Request for Additional Information 564, Supplement 4

Application Title: U. S. EPR Standard Design Certification - Docket Number 52-020

Review Section: 08.02 - Offsite Power System

Question 08.02-8:

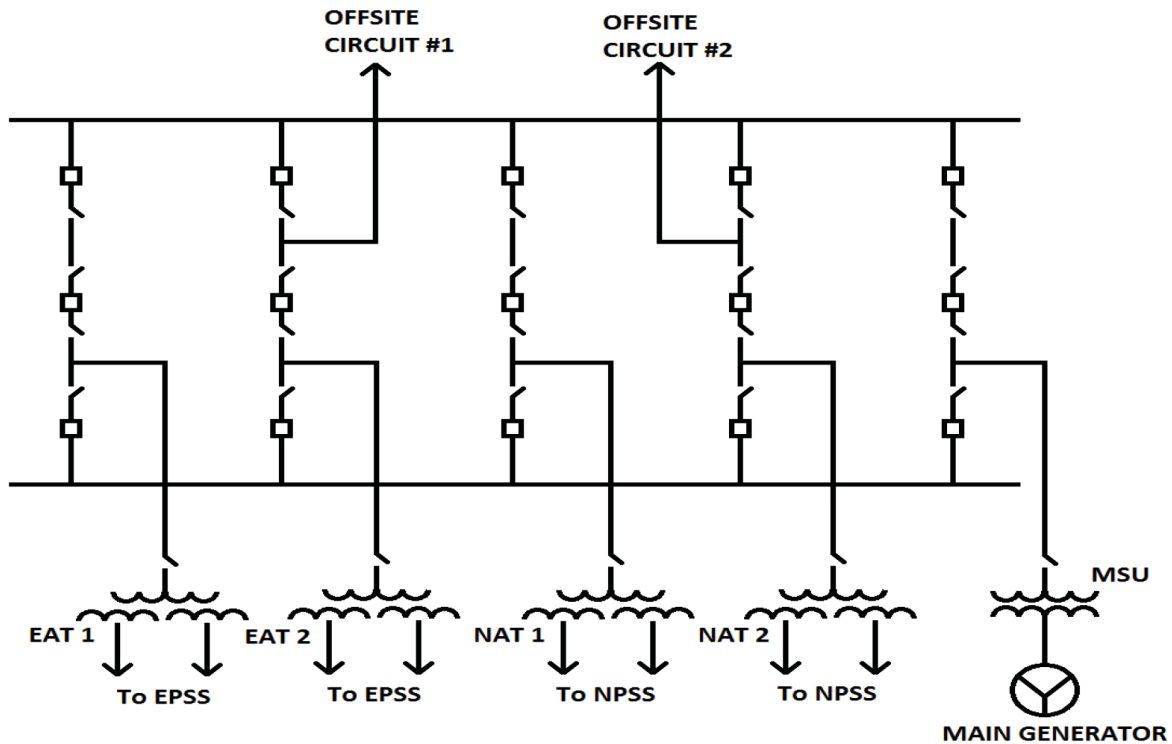
- Describe the protection scheme design for important to safety buses (31-34BDA) to detect and automatically respond to a single-phase open circuit condition or high impedance ground fault condition on credited offsite power circuits.
- If the important to safety buses are not powered by offsite power sources during at power condition, explain how the surveillance tests (e.g., SR 3.8.1.1) are performed to verify that a single-phase open circuit condition or high impedance ground fault condition on an off-site power circuit is detected.
- Describe the plant operating procedures including off-normal operating procedures, specifically calling for verification of the voltages on all three phases of the ESF buses.

The four Class 1E Emergency Power Supply System (EPSS) Buses 31-34BDA of the U.S. EPR design are powered from two, 25 MVA, 3-winding Emergency Auxiliary Transformers (EAT), 30BDT01 and 30BDT02. The three windings of each EAT are connected Wye; the primary, high-voltage side neutral is solidly grounded, and the two secondary, low-voltage side neutrals are each high-impedance grounded. Although each EAT has the capacity and capability to power all four EPSS buses (31-34BDA) under all design basis conditions, the normal operating configuration is for each EAT secondary winding to power a single EPSS bus.

The EATs are powered by dedicated off-site feeds that are not used for powering normal operation plant loads such as RCPs, Main Feedwater Pumps, etc. The Normal Auxiliary Transformers (NATs) supply the normal operations plant loads and have their own dedicated off-site power feeds. The U.S. EPR electrical system configuration also assures that should a loss of phase occur on one of the off-site feeds, the emergency buses and associated safety equipment powered by the second off-site feed are unaffected.

The U.S. EPR electrical system off-site power supply design provides a stable, dedicated and voltage regulated power source for the Emergency Buses. This configuration presents a somewhat unique relaying design challenge when trying to monitor for loss of a single off-site power supply phase due to the light loading of the EATs during normal at-power operation. This normal operating configuration maintains the EATs very lightly loaded, roughly estimated at 5 to 8 MVA each.
